TELEDYNE CONTINENTAL[®] AIRCRAFT ENGINE
MANDATORY SERVICE BULLETIN

Category 1
MSB08-2B

SUBJECT: PRECISION AIRMOTIVE LLC[®] FUEL INJECTION
SERVO RSA-5, RSA-10

SUBJECT: HEX PLUG 383493 COMING LOOSE FROM REGULATOR COVER

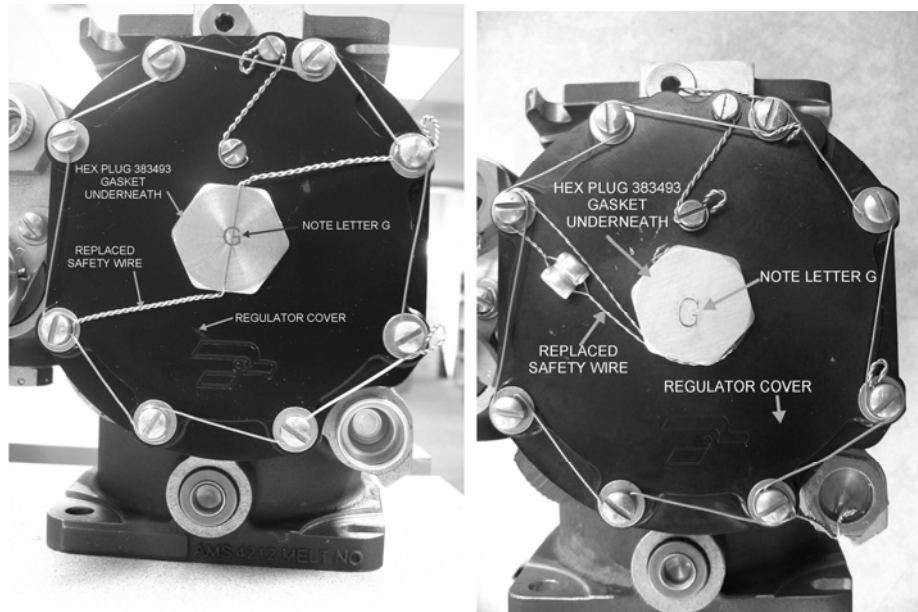
7. The hex plug must be safety wired with .015 thru .025 inch diameter wire to the regulator cover as shown in the photos on the next page. The wire shall pass thru the plug such that it pulls the plug in the tightened direction and does not rest on the corners of the hex on the plug (it is acceptable to wrap under the corners of the hex plug). These photos are just two examples of acceptable safety methods. Other safety wire methods such as those described in FAA AC 43-13-1B (or latest revision) are also acceptable.

Note: The safety wire through the hex plug shown in the left hand photo is .025" wire wrapped around regulator screws under existing wire. It does not go through the holes in the screws. The safety wire through the hex plug shown in the right hand photo is .015" wire which passes through the regulator screw hole. This is the normal safety wire method used at the factory.

IMPORTANT: The letter "G" shown in the photos is to be stamped **ONLY** if the new gasket, part number 2577258 has been installed.
